Topcon Sokkia announces an update to the SHC5000/6000 RAM Clip Mount Kit

Part Number 1015317-01

How to identify a defective Pole Clamp with Ball:

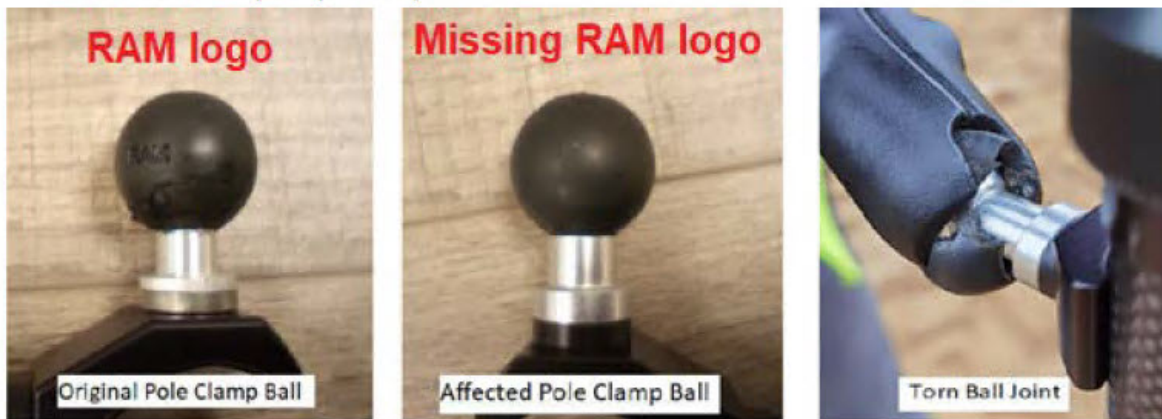
A change made by the supplier to the mounting ball used in the FC/SHC5000/6000 ram clip mount kit may result in an early failure of the ball joint when the clamp is not loosened to adjust the mount. This strain can cause a crack in the rubber ball and failure to support the tablet. The issue has been resolved. There is a potential for product to be out in the field that may cause a premature failure.

The affected product can be identified by its matte finish and the absence of the "RAM" logo imprinted on the ball. (See photos)

The FC/SHC5000/6000 Ram Clip Mount Kit contains three parts, The Pole Clamp with Ball, Arm and Mount. *Please only return the defective Pole Clamp with Ball P/N 1059582-01 for replacement.*

Please inspect the pole clamp with ball and contact Topcon customer service for an RMA to replace. Replacements may not be available immediately and will be shipped on a first come-first served basis. The replacement program will end January 31, 2023.
